SUBJECT Response to Request for More Information
Derry-Londonderry, 13065
DES File #2018-03134

RESPONSE TO NHDES REQUEST FOR MORE INFORMATION
NHDES # 2018-03134

TROLLEY CAR LANE STREAM RELOCATION
LONDONDERRY, NEW HAMPSHIRE

RESPONSE TO NHDES REQUEST FOR MORE INFORMATION
NHDES # 2018-03134

HYDROCAD™ ROUTING DIAGRAM AND FLOW LOCATIONS

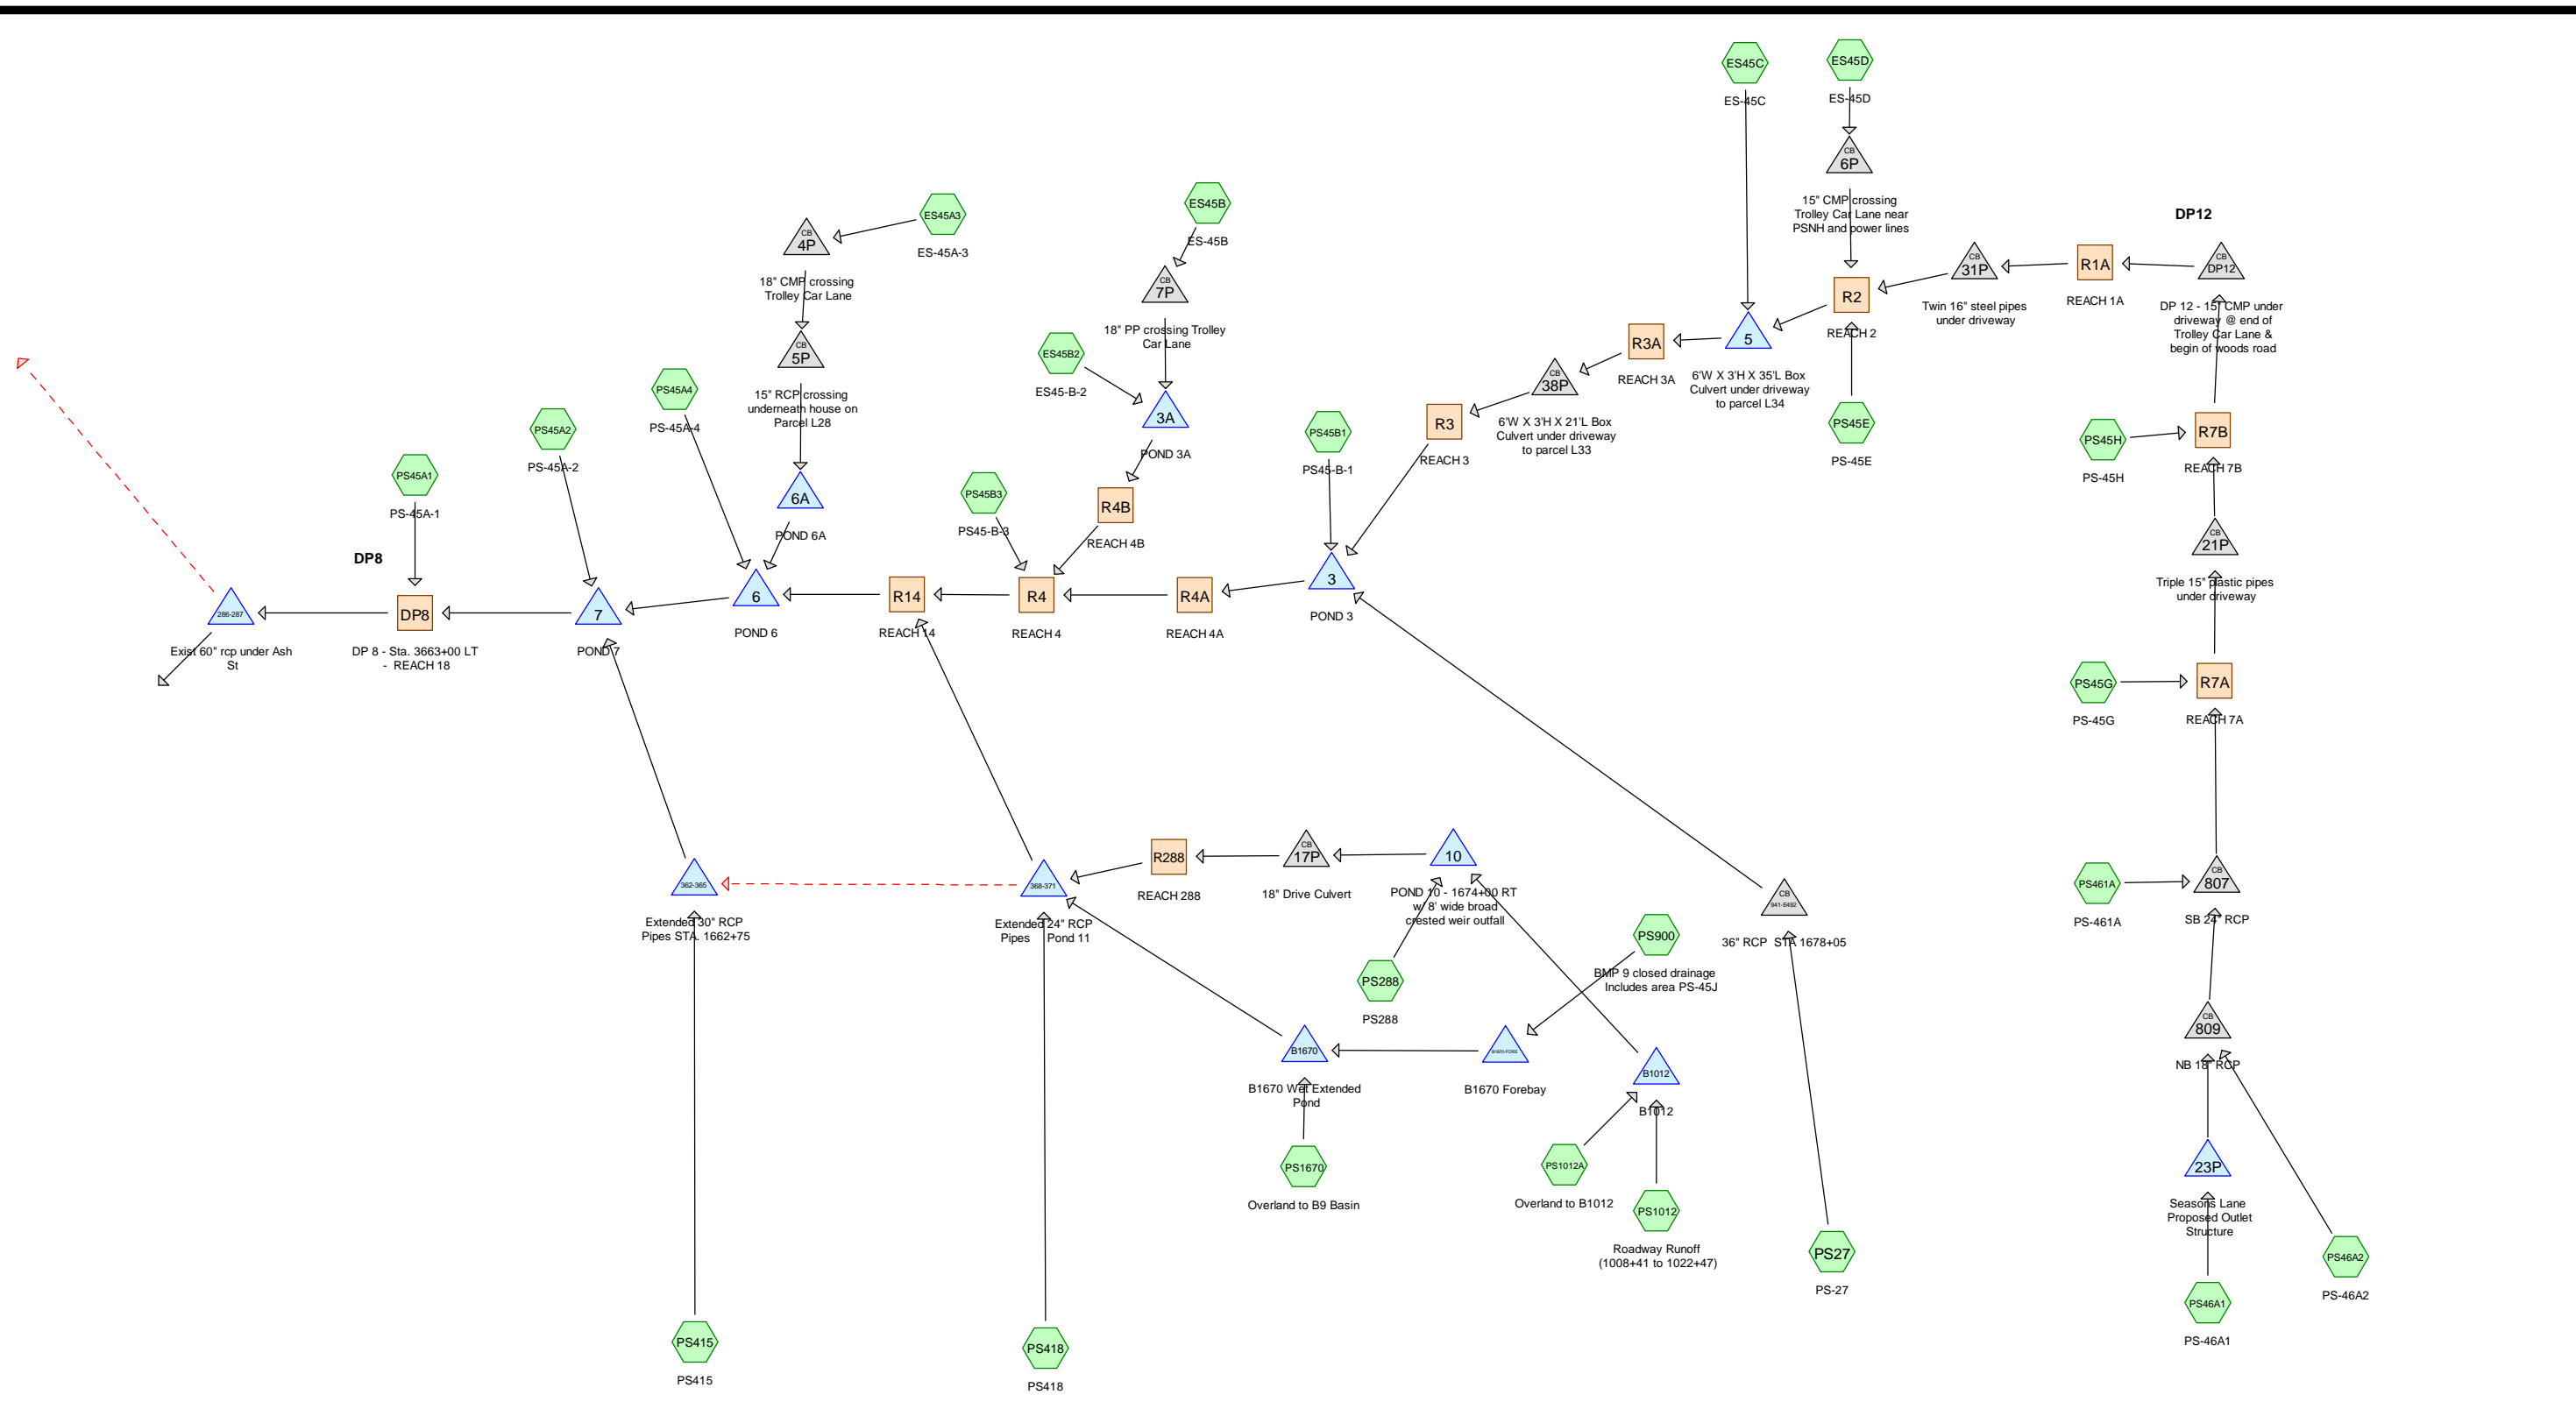
- Bank full width
- Entrenchment Ratio
- Sinuosity
- Net floodplain
- Existing forested buffer
- Native planting plan
- Stream bed simulation material
- Longitudinal profile and grading plan
- Accommodate perpendicular tributary flows to Trolley Car stream
- Accommodate for any increased flow volume due to additional impervious (BFW/ER)
- Methodology of stream reconstruction

Within this watershed, three separate detention areas have been utilized to mitigate the loss of flood storage and attenuate flows as a result of the I-93 and Exit 4A projects; existing B1670, proposed B1012 and a modified detention basin on Seasons Lane. B1670 modeling was updated to ensure that both treatment of the WQV and flood storage of the 50-year event could be provided within the existing basin. B1012 was sized to provide infiltration of the entire 50-year event. The existing detention basin on Seasons Lane was increased in size to provide additional detention of the 50-year event. At the point of interest (inlet of node 286-287 "Existing 60" RCP under Ash St.") the inflow runoff volume (50-year 24-hour storm) has decreased from 73.71 ac-ft (Pre I-93) / 70.96 ac-ft (Post I-93/Pre Exit 4A) to 70.22 ac-ft (Post Exit 4A) and the inflow peak runoff decreased from 152.63cfs (Post I-93 / Pre Exit 4A) to 152.04cfs (Post Exit 4A). Below is a summary table (Table 2) of the flows along the Trolley Car Lane Stream for Pre I-93, Post I-93 and Post Exit 4A. The delta column shows the change from Post I-93/Pre

Exit 4A to Post Exit 4A. The HydroCAD™ Routing Diagram for the Post Exit 4A model and a plans depicting the location of the flows below are included in Attachment E for reference. Full hydrologic models are available upon request.
